**Generic design assessment
AP1000 nuclear power plant design by
Westinghouse Electric Company LLC**

**Assessment report
Other environmental
regulations**

Assessment report – other environmental regulations

39 The effluent system of the AP1000 is shown in ER Figure 6.2-2:

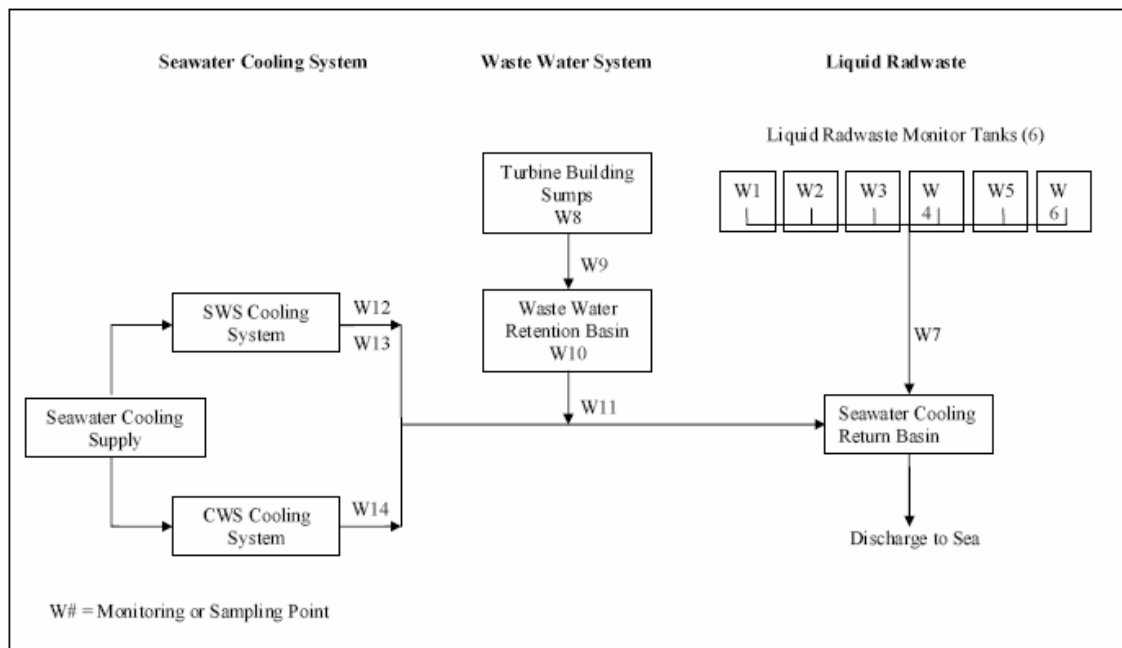
40 We would place controls on four effluent release points in a permit:

- W7 – discharge for liquid radwaste monitor tanks serving the liquid radioactive waste system (WLS);
- W11 – discharge line of the wastewater system (WWS) from the wastewater retention basin;
- W14 – discharge line of the circulating water system (CWS);
- W12 – discharge line of the service water system (SWS).

- effluent from the liquid radwaste system discharged through point W7 (WLS)(ERs3.4.3). The radioactivity of this effluent is dealt with in our report EAGDAR AP1000-05 (Environment Agency 2010c) but the effluent will also contain chemicals and metals, e.g. corrosion products, that will need to be covered in a discharge permit from us and which therefore merit consideration here;
- effluent from the Wastewater system (WWS) that serves the drains in the non-radioactive building areas of the AP1000. The effluent is collected in sumps and then pumped through an oil separator to the wastewater retention basin for settling of suspended solids and treatment, if required. The basin is discharged, after sampling and appropriate discharge approval, to the seawater return sump through point W11, (ERs4.2.1.1 and ER Figure 6.2-2).

Westinghouse claim that the wastewater retention basin also has sufficient volume to retain any unplanned emissions of effluents or spillages. Effluents that cannot be discharged can then be treated or disposed of off-site (ERs4.2.6.1).

Westinghouse state that the design of the wastewater retention basin is a site specific matter and have not provided any detailed information. We have therefore not been able to assess this aspect at GDA. The Operator will be required to submit the design details including justification of retention volume to support a site specific permit application.

117 A schematic showing the proposed treatment and disposal of non-radioactive waste is shown in Figure 4.3-1 of the ER:

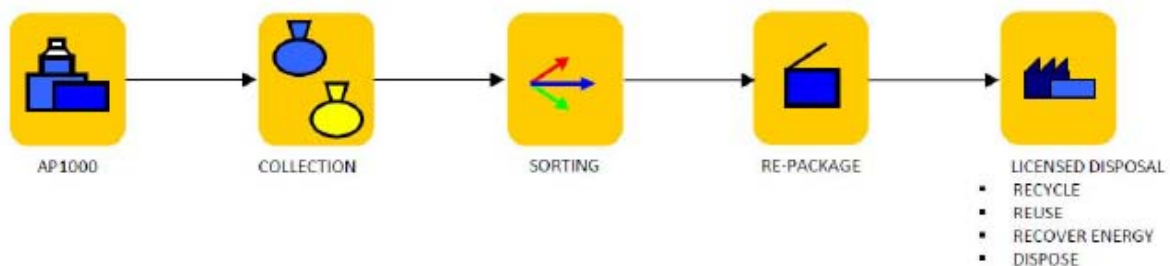
- 118 We conclude that Westinghouse's strategy and proposals for the management of non-radioactive waste are consistent with:
- a) the waste hierarchy;
 - b) the Waste Framework Directive objective that waste is recovered or disposed of without endangering human health and without using processes or methods that could harm the environment;
 - c) the requirement of *The Environmental Protection Act 1990* (EPA 90) that waste shall not be treated, kept or disposed of in a manner likely to cause environmental pollution or harm to human health;
 - d) the duty under EPA 90 to take reasonable measures to prevent waste from escaping.
- 119 However, Westinghouse has not included waste from construction activities in its waste strategy, so this is required for each site at site-specific permitting.
